GENT
by Honeywell

Technical Bulletin

TB 10228 | November 2019

Gent Mains Interface (S4-34440-02 and/or S4-34440-12) Changes to PCB

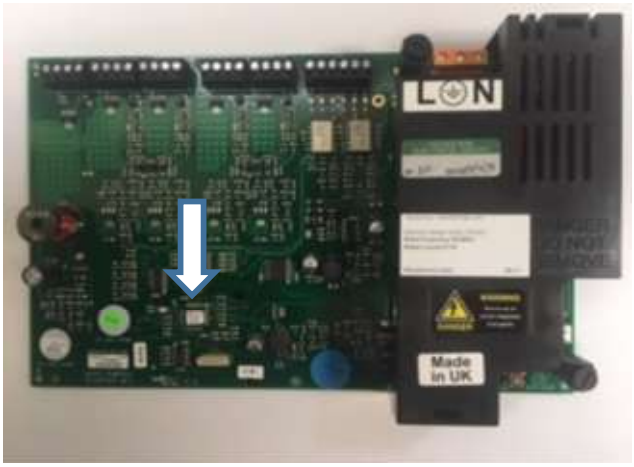
We have made changes to the Mains powered interface to support new intrinsically safe offering of peripherals and barriers.

Boards made from the start of October 2019 are now version 1.04. See below picture for chip location with version number

These alterations have changed the end of line used for sounder circuits and barrier for the intrinsically safe offering.

Make sure all engineers are aware of this change.
If carrying out new install or replacing existing mains interface PCB's please review these changes as they may require other changes on site.
For more information on this please see the mains interface manual 4188-968 issue 8 on gent expert (downloads / manuals and datasheets / addressable loop devices / mains interface)
